CSP 26-006AL (BP030) – ADDENDUM No.01
Willowridge HS Renovations

Fort Bend Independent School District
2023 Bond Program

addendum

PROJECT BP030 Willowridge High School Fine Arts Addition and Renovation, 2023306
PROJECT NO. CSP 26-006AL
ADDENDUM NO. 001
BID PACKAGE ISSUE FOR BID AND PERMIT

1 LEVEL 1 PLUMBING PLAN - AREA B1
1/8" = 1'-0"

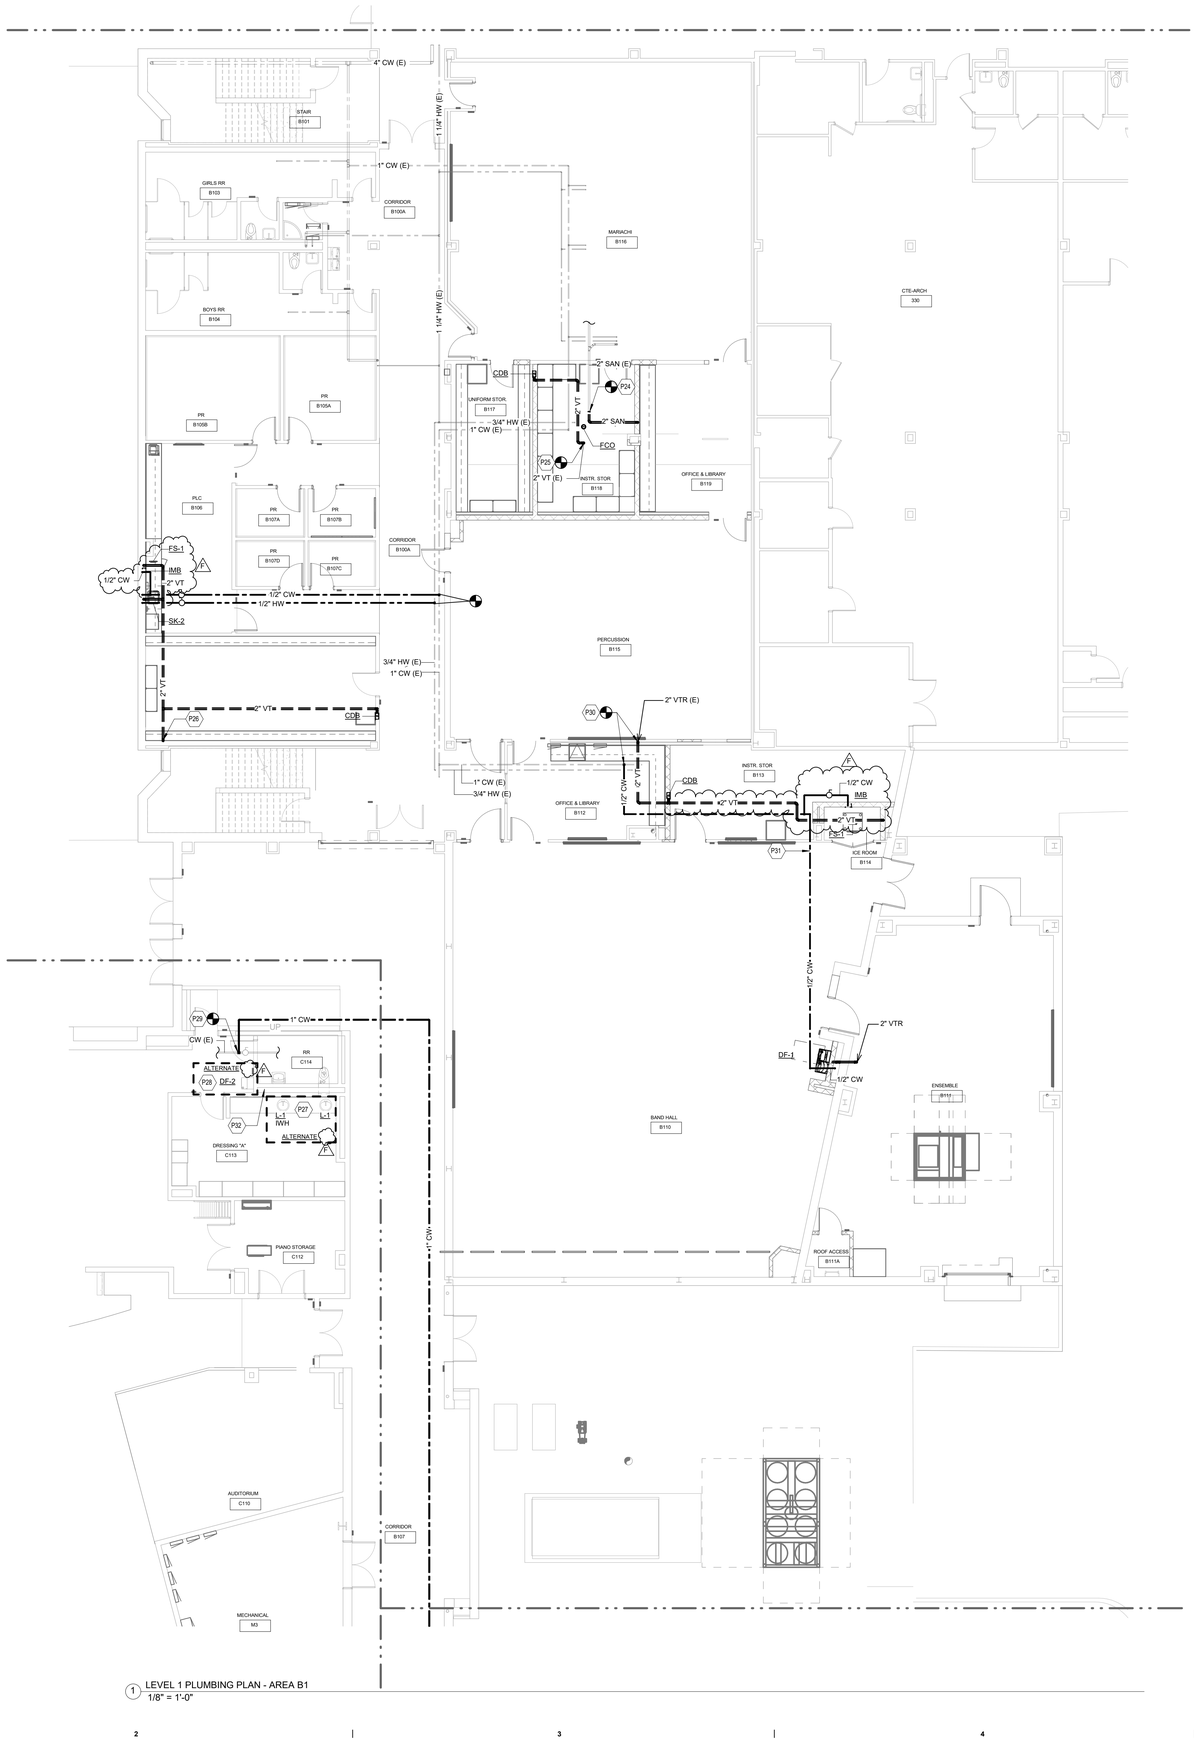
P2.31 LEVEL 1 PLUMBING PLAN - AREA B1

1. Added IMB, FS-1 and to serve ice maker.
2. Added 1/2" CW to connect to ice maker wall box.
3. Added sanitary and vent piping to serve FS-1 at ice maker.
4. Added keynotes.

1 LEVEL 1 PLUMBING PLAN - AREA B2
1/8" = 1'-0"

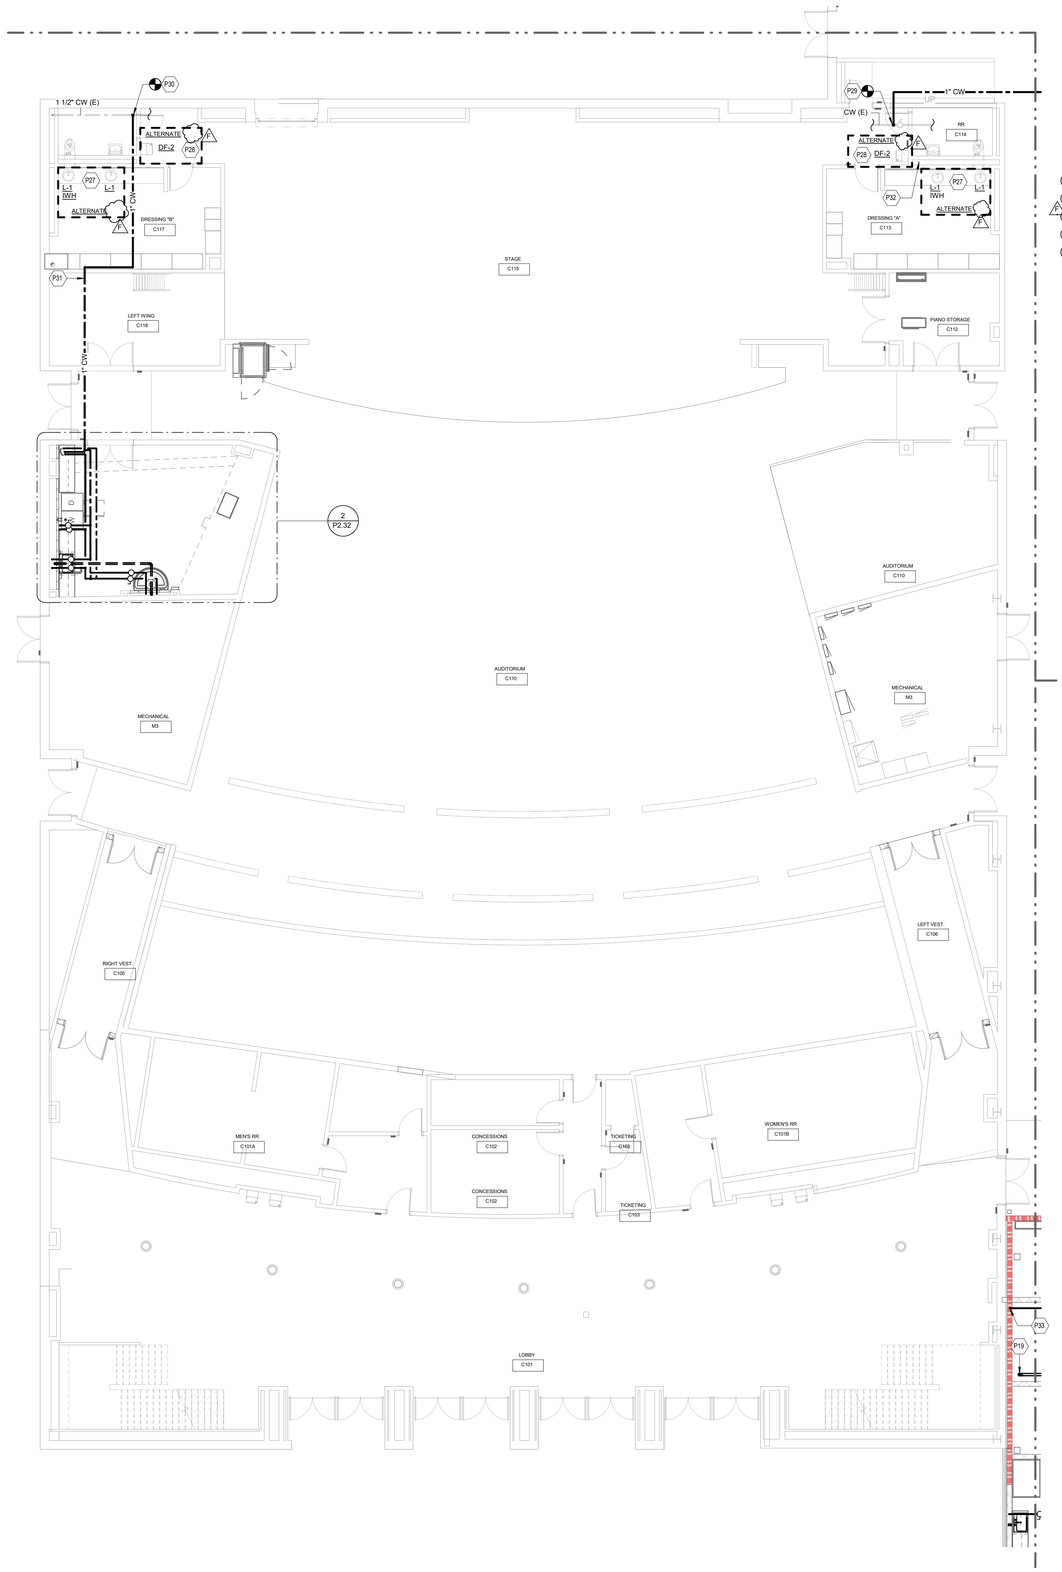
P2.32 LEVEL 1 PLUMBING PLAN - AREA B2

1. Revised water line sizes serving fixtures in Scene Shop.
2. Added 2" vent piping.
3. Revised water and drain to serve commercial washing machine.
4. Removed washing machine drain box.
5. Added keynotes.

SHEET NUMBER
T2.31

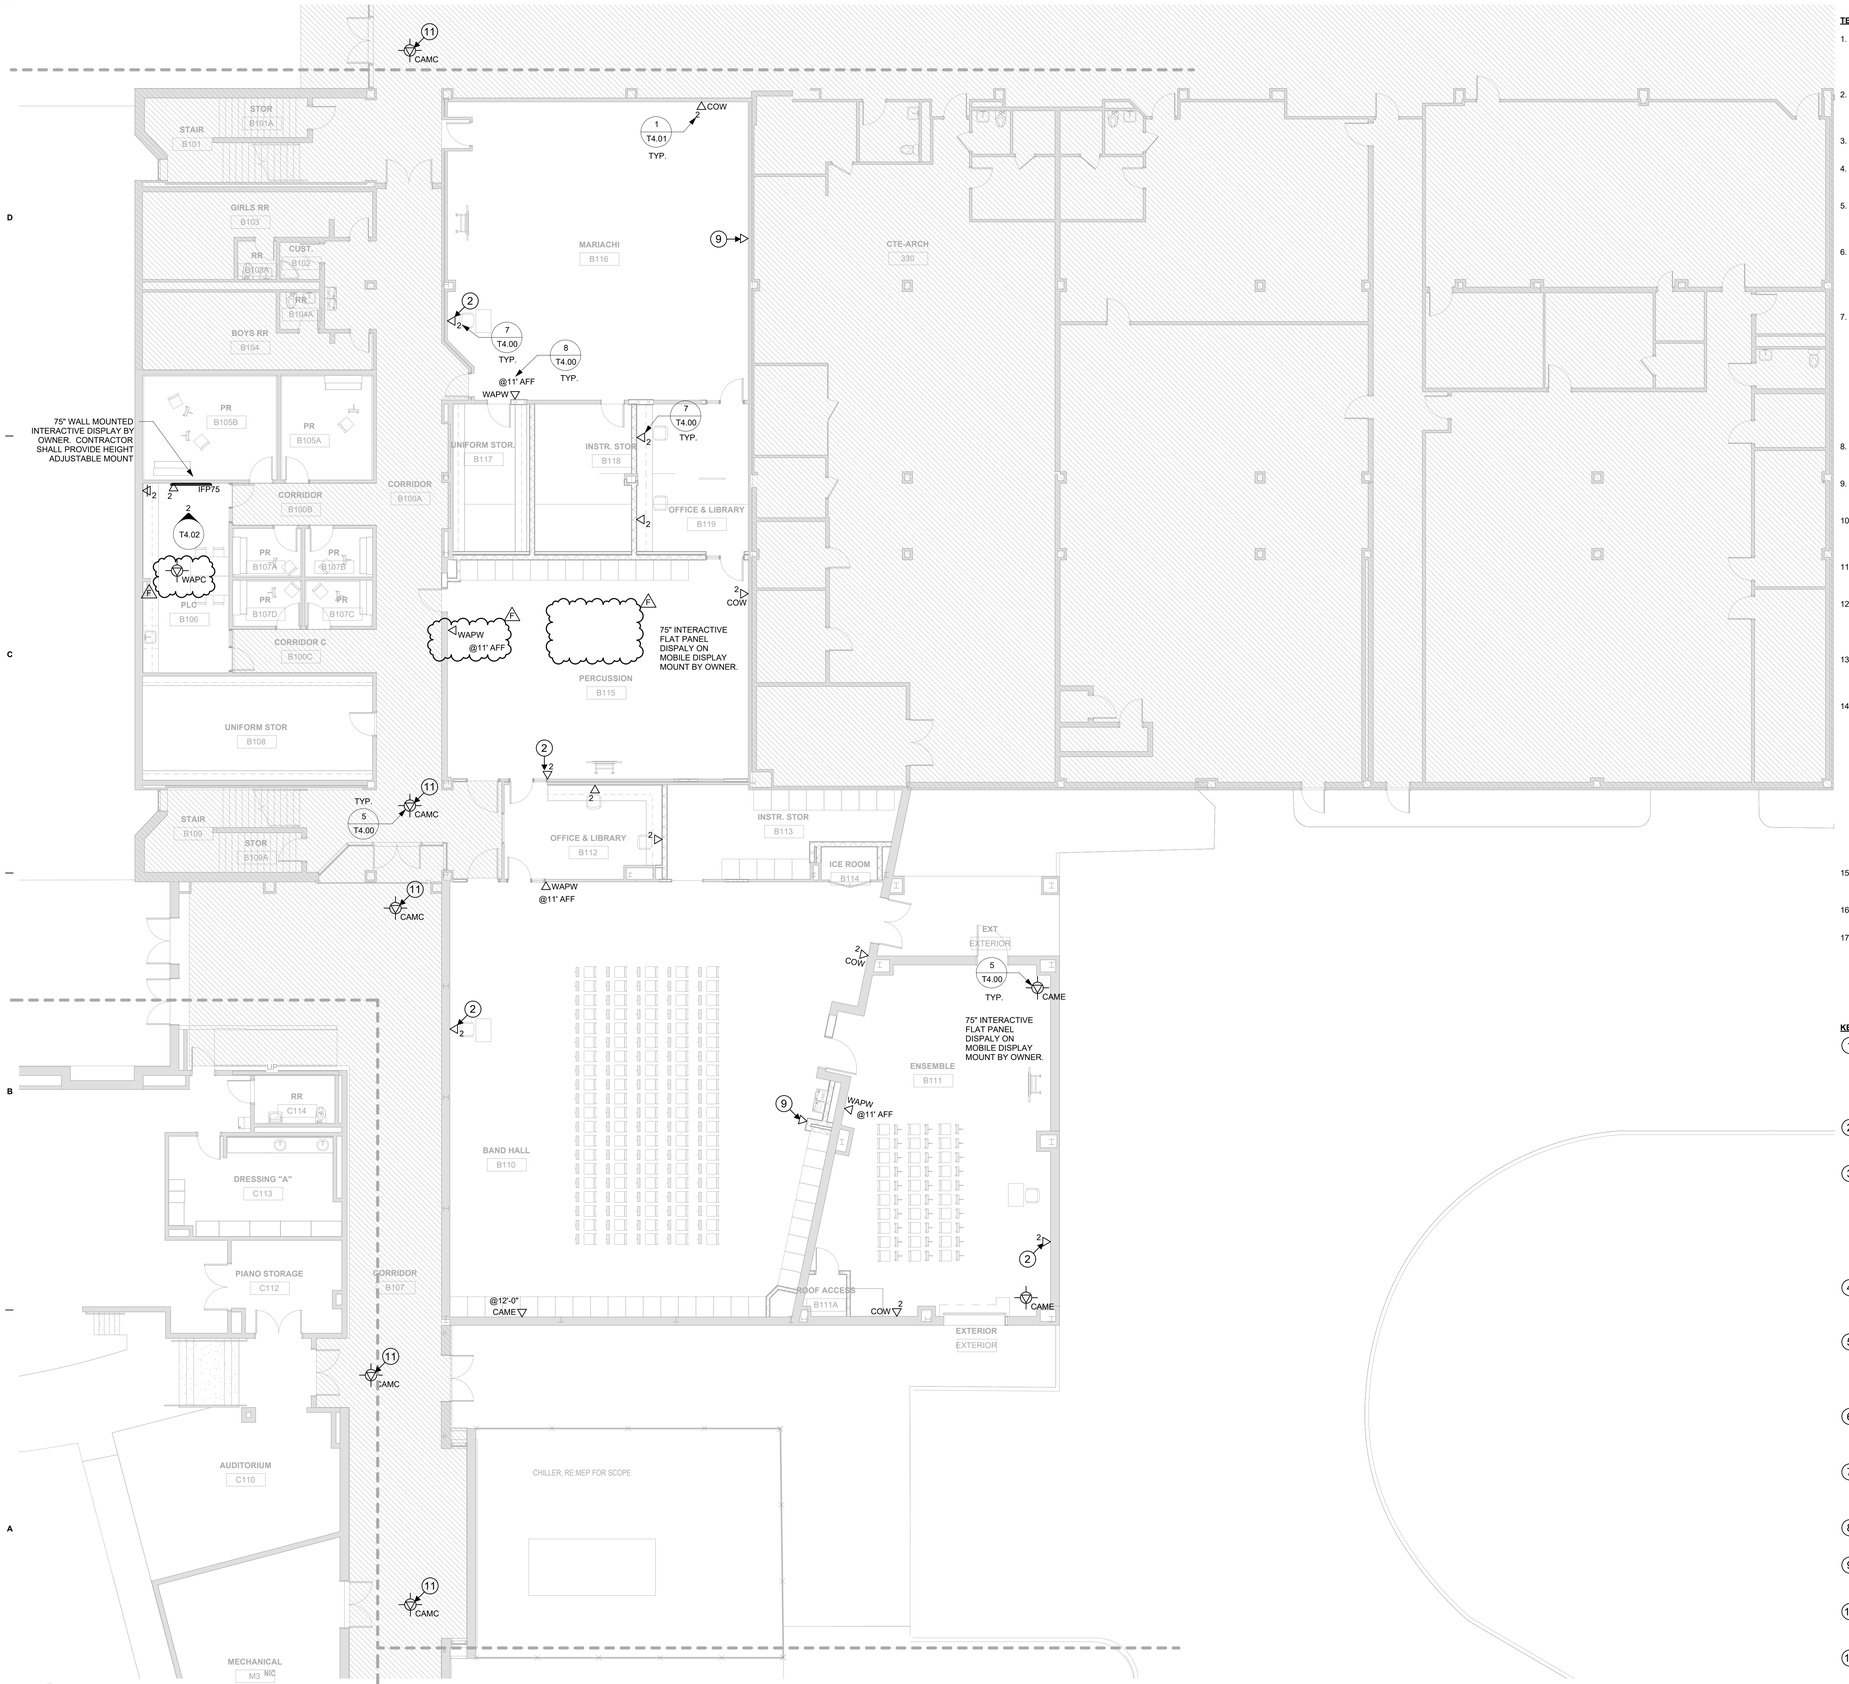
T2.31 TECHNOLOGY LEVE 1 – FLOOR PLAN – AREA B1

1. Detail 1- removed reference of destination room, clarified panel #
2. Detail 3 – revised detail to show panel termination preferences and type, removed reference to high-pair count backbone copper cable.

SHEET NUMBER
TS2.33

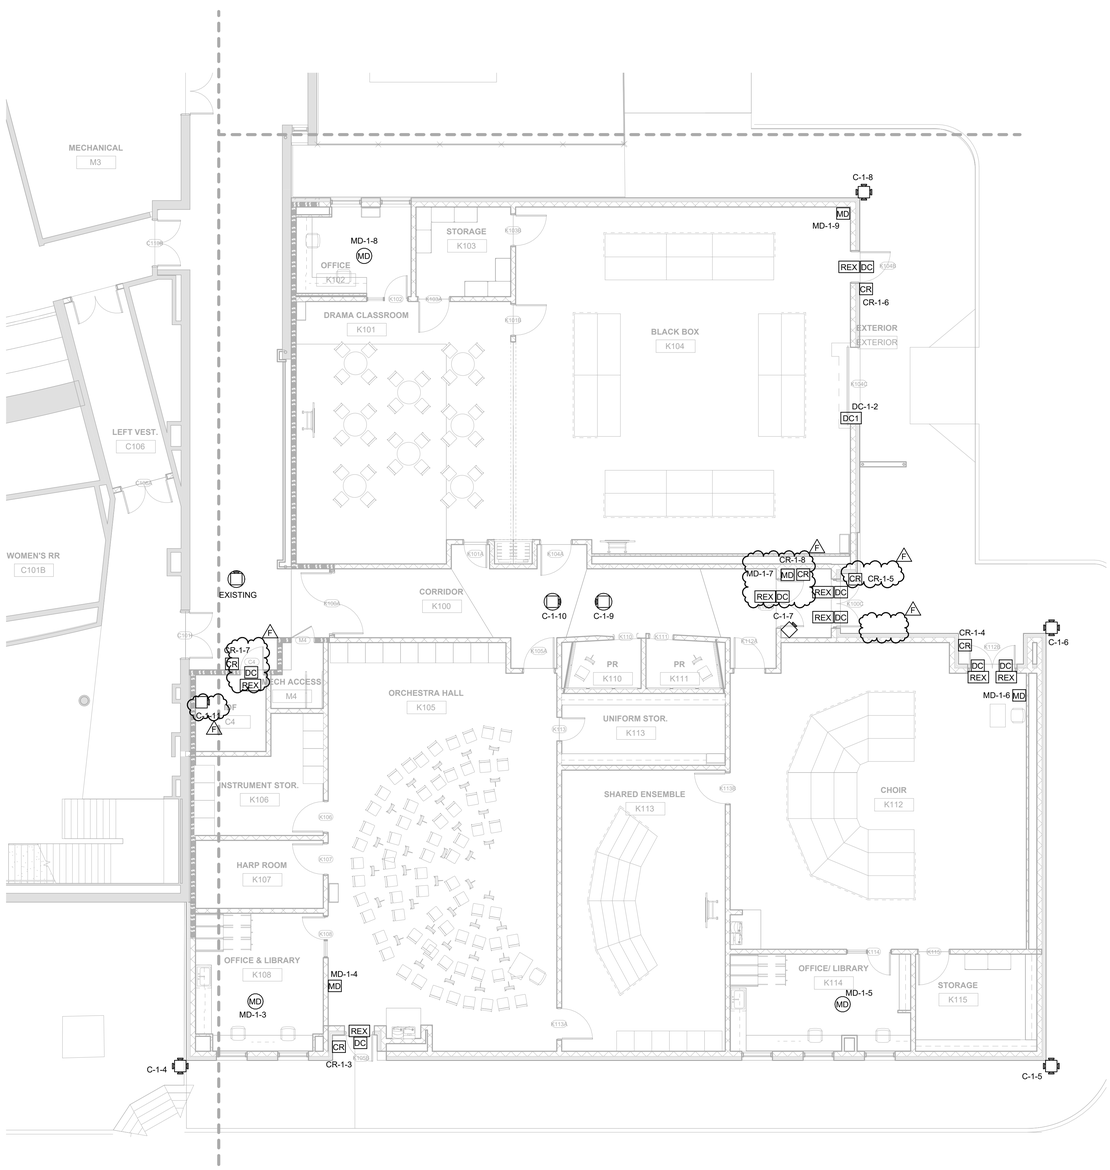
TS2.33 – SECURITY LEVEL 1 – FLOOR PLAN – AREA B3
